Wiring deltas of easYgen-3400/3500-P1/P2 versus easYgen-3400XT/3500XT-P1/P2

Clemens - 2024-09-27 - easYgen-3000XT

Communication Interfaces:

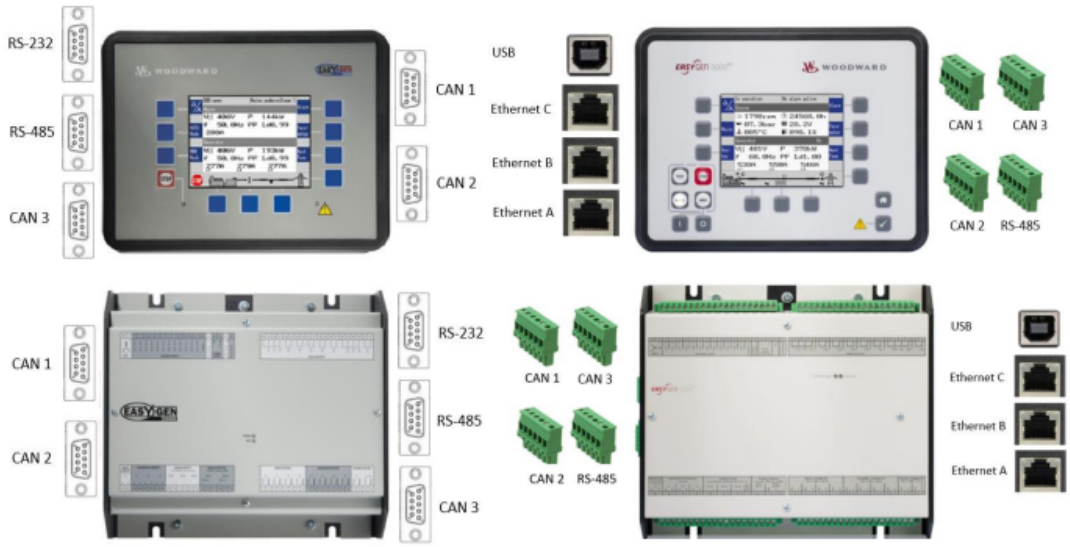
Old easYgen-3000 had D-sub sockets. RS232 port is used for Toolkit configuration. In easYgen-3000XT RS232 port was replaced by a USB 2.0 service port socket. In easYgen-3000XT D-sub sockets are replaced by terminals.
